High Crash Corridors Analysis

Road Safety Audit Report for Wickham Road from Sarno Road to Parkway Drive

Project Title: Wickham Road Safety Audit - Sarno Road to Parkway Drive

Figure 51 Illustration of Negative, No, and Positive Offset Left-turn Lanes (Source: FHWA Safety Evaluation of Offset Improvements for Left-Turn Lanes)

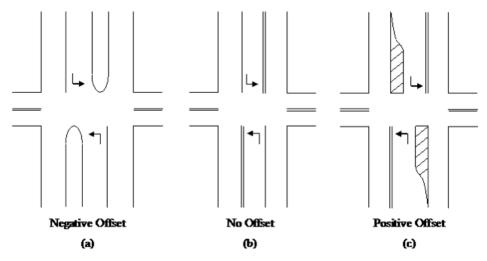
Wickham Road has exclusive left-turn lanes on the north and south approaches at all signalized intersections along the study corridor (Eau Gallie Boulevard shown in Figure 50) and in all cases, the left-turn phase is protected-permissive with a "doghouse" five-section signal head. The turn lanes also have a negative offset, as illustrated in Case "a" in Figure 51. The negative offset limits sight distance for northbound/southbound left-turn vehicles during the permissive left-turn phase by opposing left-turn vehicles. Left-turn crashes represent 13 percent of all crashes within the study area and are primary crash types at the following signalized intersections:

- In the near-term, replace "doghouse" five-section signal displays with 4-section flashing yellow arrow (FYA) protected/permissive left-turn display.
 - If the left-turn phasing is converted to a FYA display, consider providing protected only left-turn phasing during peak periods and allow the protected-permissive phasing during the off-peak periods.
- In the longer term, realign the northbound and southbound approaches to provide a positive offset to improve sight distance.
 - On the Wickham Road approaches to Eau Gallie Boulevard, shift the median to the right-hand side of the left-turn lane, as shown in **Figure 51(c)**.

Figure 99

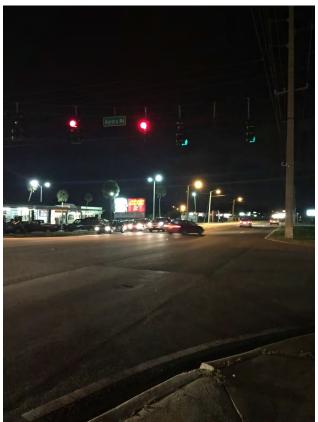
The majority of the corridor has illumination, except between Aurora Road and Lake Washington Road where several lights were out of service (see **Figure 99**). There were 154 reported crashes between Aurora Road and Lake Washington Road. The crash history indicated that 20 percent of the crashes along the corridor occurred under dark lighting conditions (dawn, dusk, dark-lighted, and dark-unlighted).

As a maintenance-type improvement, consider contacting the operator/maintainer to replace the luminaires at the following locations:

• Repair/replace applicable street lights between Aurora Road and Lake Washington Road

Figure 102

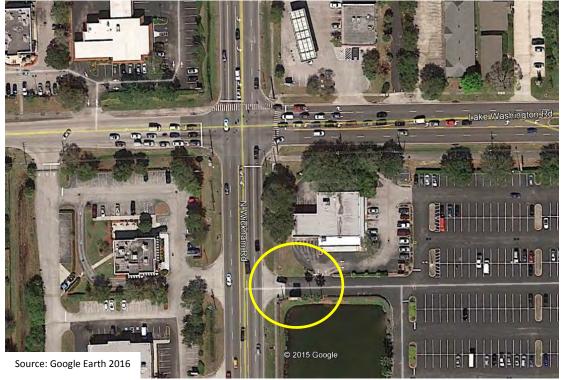
A driveway that serves the Lake Washington Plaza is located within 225 feet of the Lake Washington Road signal (shown in **Figure 102**). Outbound left-turns from the driveway conflict with northbound approach queues. Over the crash analysis period, 13 angle crashes were identified at the driveway

location denoted in **Figure 102**. Twenty-eight (28) angle crashes occurred at the Lake Washington Road intersection with 23 crashes occurring at a driveway within the influence area of the signal.
